1998 - 1999 Corvette: Service Bulletin: Tech - Service Engine Soon (SES) Light Illuminates (Repl Switch Assy)

Source: Chevrolet Dealer Technical Service Bulletin

Number: 99-07-30-013

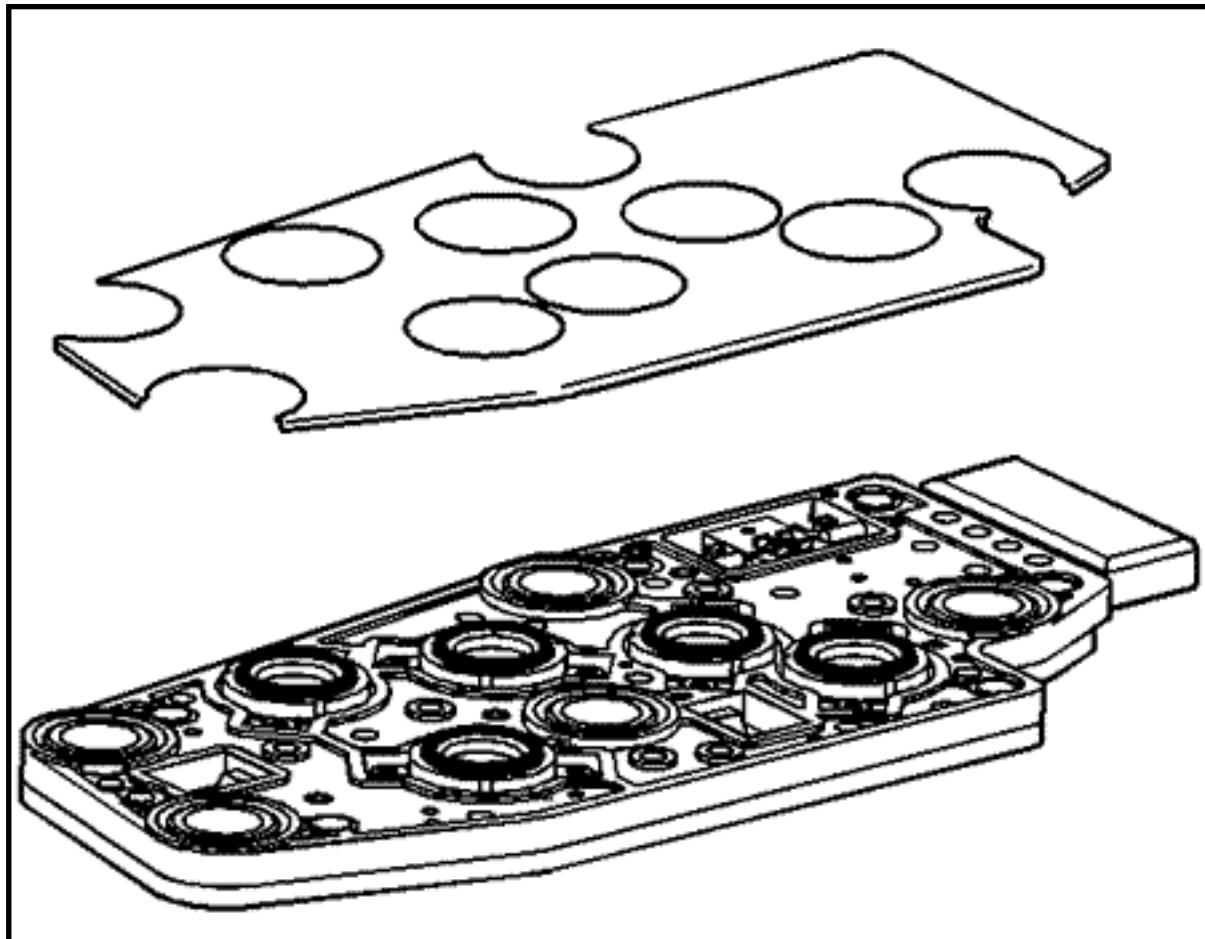
Debris from aluminum shavings, bronze material, and certain clutch material may cause the pressure switches in the TFP switch assembly to stick or electrically short out.

A new TFP switch assembly with a plastic shield has been released. The plastic shield is designed to protect the pressure switch from debris. This improvement will reduce the likelihood of a DTC P1810. This product change went into production on April 8, 1999 (Julian date 098). The existing TFP switch assembly remains relatively unchanged except for the addition of the new shield, creating a new part number for the assembly. The shield fits over the existing TFP switch assembly and is not sold separately.

Follow diagnostics for the P1810 Diagnostic Trouble Code in the Transmission Section of the appropriate Service Manual. If the diagnostics indicate that switch replacement is necessary, use the correct switch P/N as listed below.
